Planning and Zoning Commission Meeting

**Planning and Zoning Commission Meeting
Staff Report
January 15, 2025**

PRELIMINARY DEVELOPMENT PLANS
FOR
HIGH COUNTRY
PHASE 10

RE: Comment Response to Preliminary Plat Review
High Country Phase 10 – Preliminary Plat

BHC Review
11-20-2024

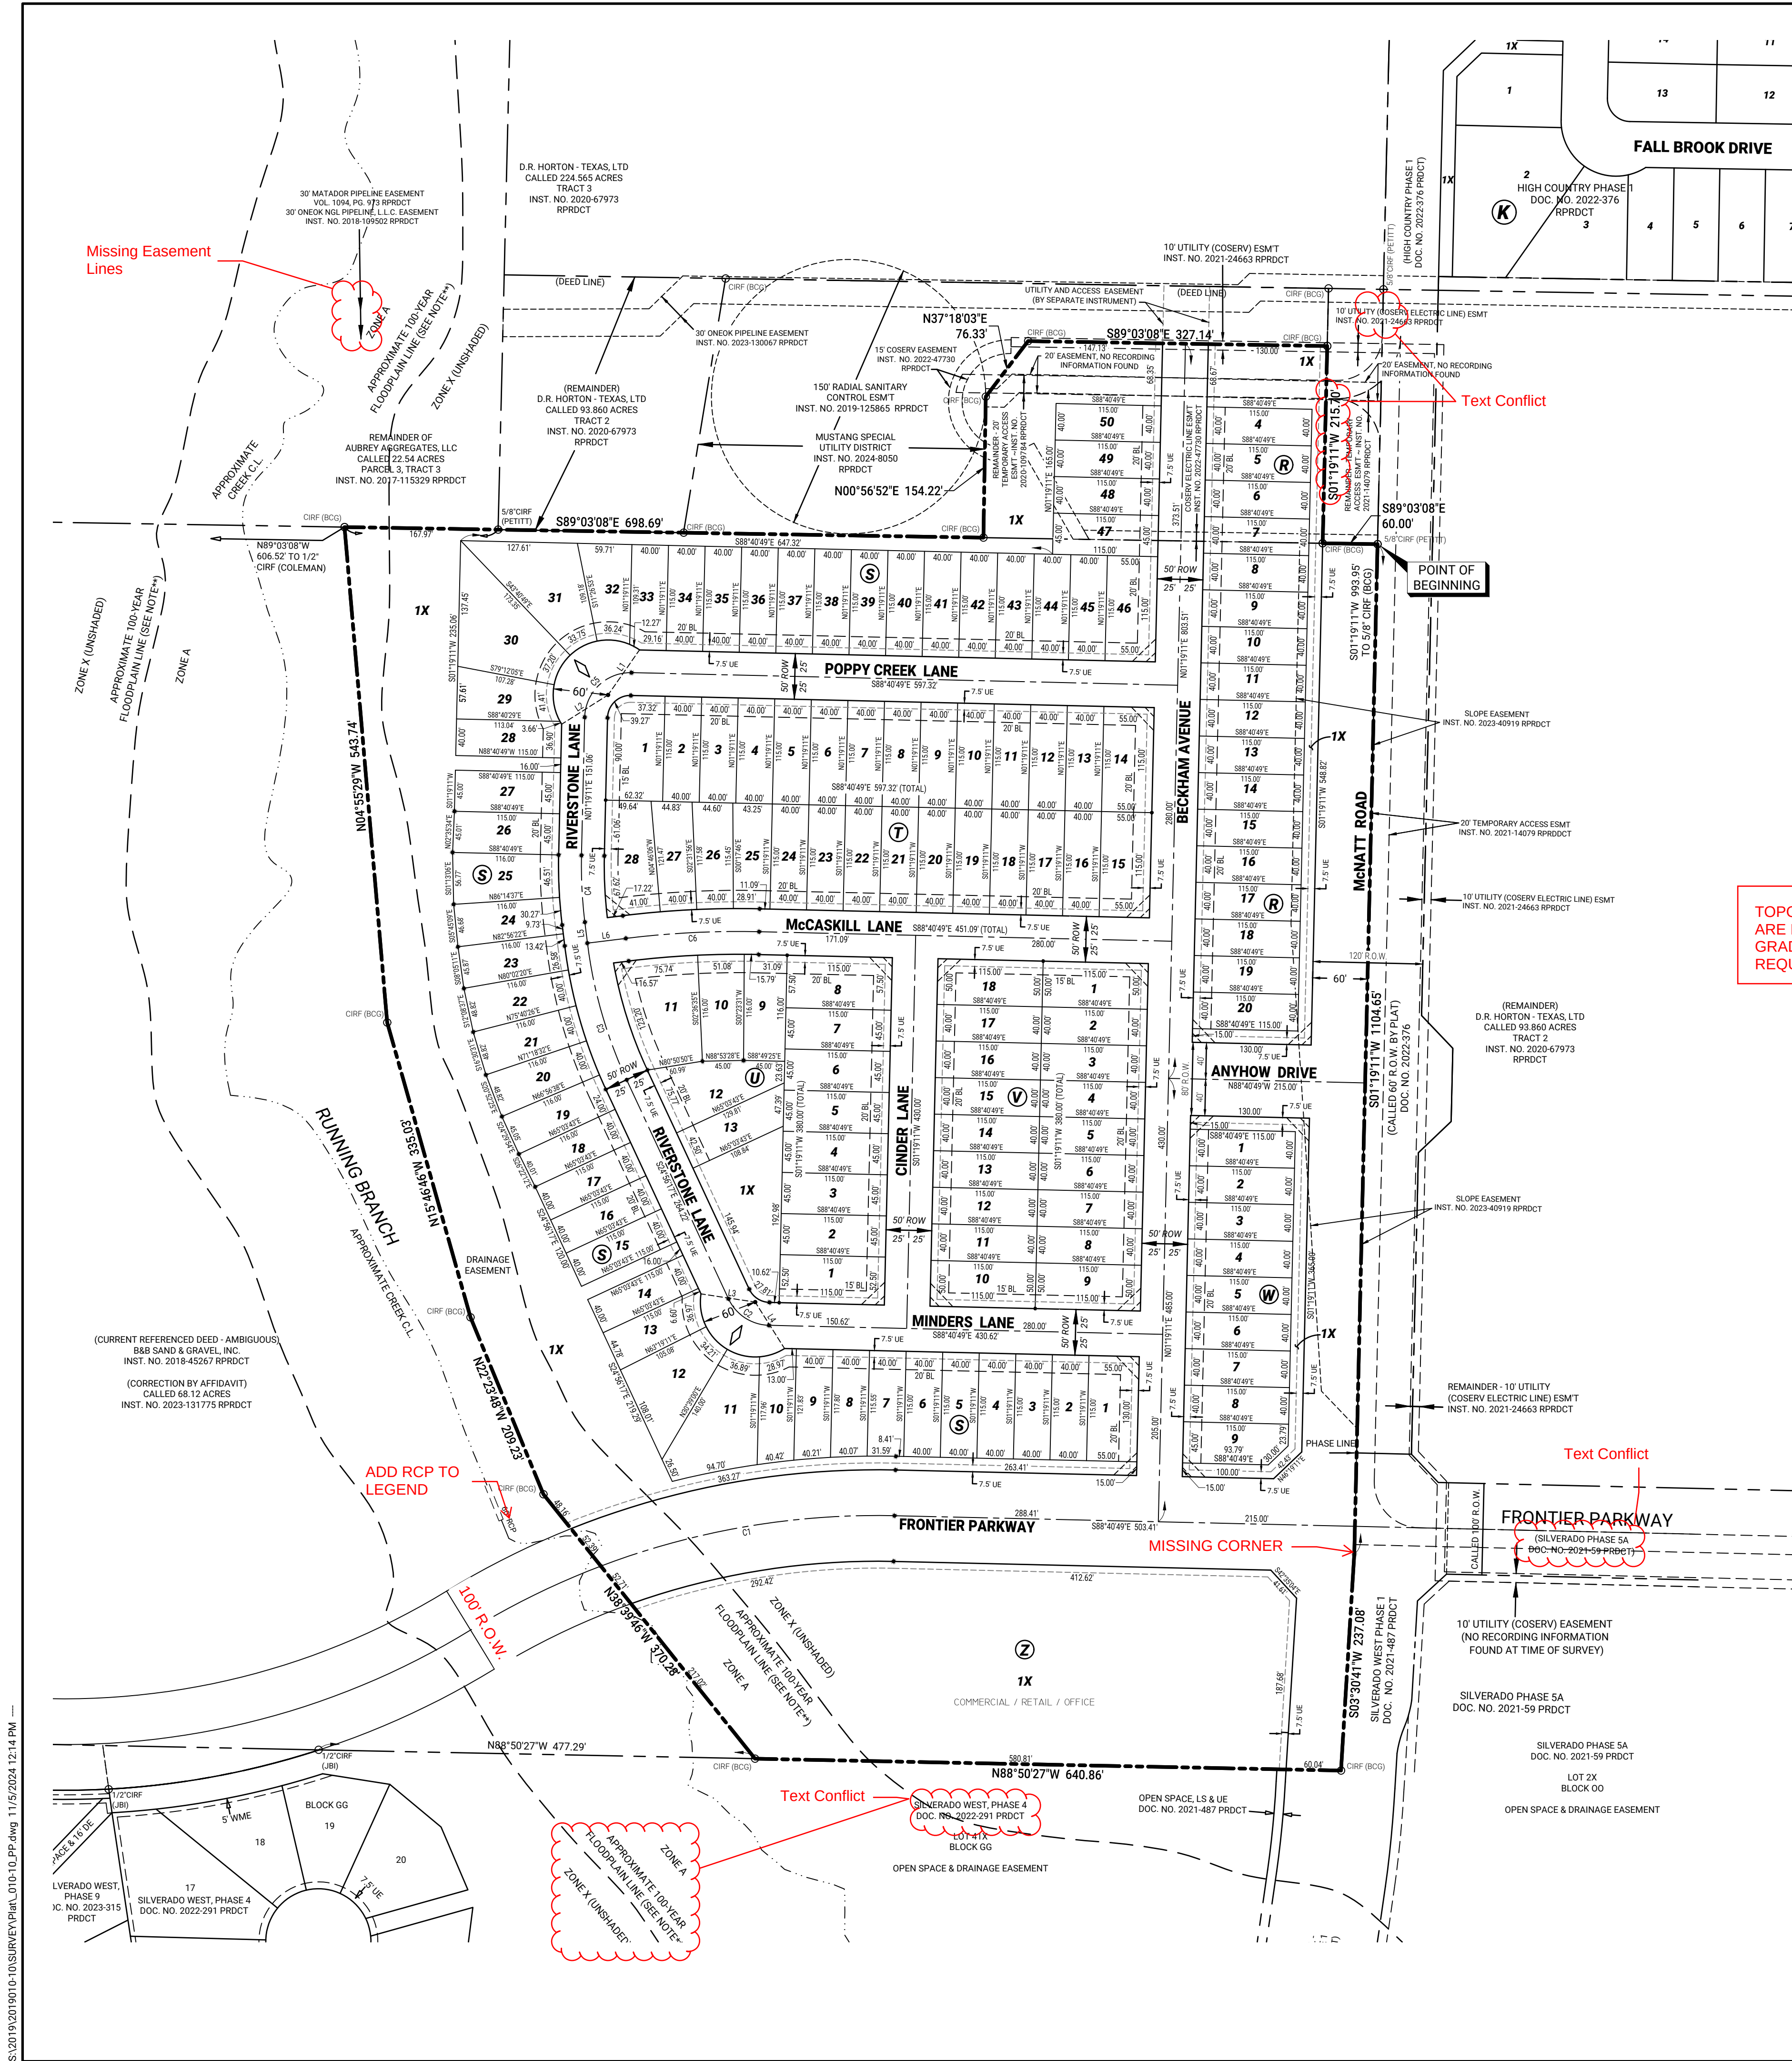
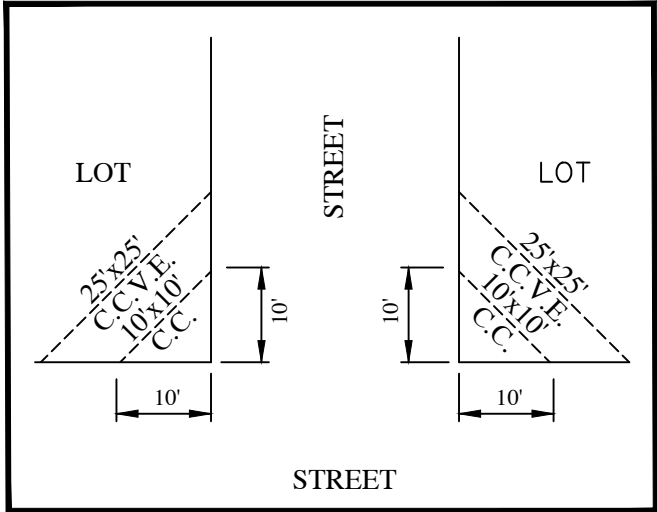
TOPOGRAPHICAL INFORMATION WITH CONTOUR LINES ARE REQUIRED FOR PRELIMINARY PLATS, PRELIMINARY GRADING, WATER, & SEWER SHEETS MISSING - PER CITY REQUIREMENTS

15. THE BEARINGS SHOWN AND RECITED HEREON ARE REFERENCED TO THE MONUMENTED EAST LINE OF HIGH COUNTRY PHASE 1, AN ADDITION TO DENTON COUNTY, TEXAS RECORDED IN DOCUMENT NO. 2022-376, PLAT RECORDS OF DENTON COUNTY, TEXAS (S01'48'23"W). ARE DISTANCES SHOW IN GRID OR SURFACE?

28. Note #15: Are distances shown in grid or surface?
 - a. Addressed. Note#15 updated (surface)
29. Owner's Certification: 2nd Paragraph shows "BCG 10194538", but plat shows "Pettit Cap".
 - a. Addressed. Owner's Certification: 2nd Paragraph has been updated to show "PETTIT" and matches what plat shows.
30. Owner's Certification: 5th Paragraph should be 60.04 feet?
 - a. Addressed. Owner's Certification: 5th Paragraph has been updated to show 60.04 feet.
31. Owner's Certification: 7th Paragraph – add "to a 5/8" iron rod".
 - a. "Said iron rod" refers to the 5/8-inch rod mentioned above. Correct as written.
32. Owner's Certification: 12th Paragraph – replace metes and bounds with "S 89 03' 08" E".
 - a. Owner's Certification: 12th Paragraph- metes and bounds has been replaced with "S 89 03' 08" E".

1. Provided by our third-party consultants, Birkhoff, Hendricks, & Carter (see attached).
Topographical information with contour lines are required for preliminary plats. Preliminary Grading, Water, and Sewer sheets are missing as per City requirements.
 - a. Topographical information with contour lines are provided in the preliminary storm plans
 - b. A Preliminary Civil Set has been submitted with Preliminary Grading, Water, and Sewer sheets as required.
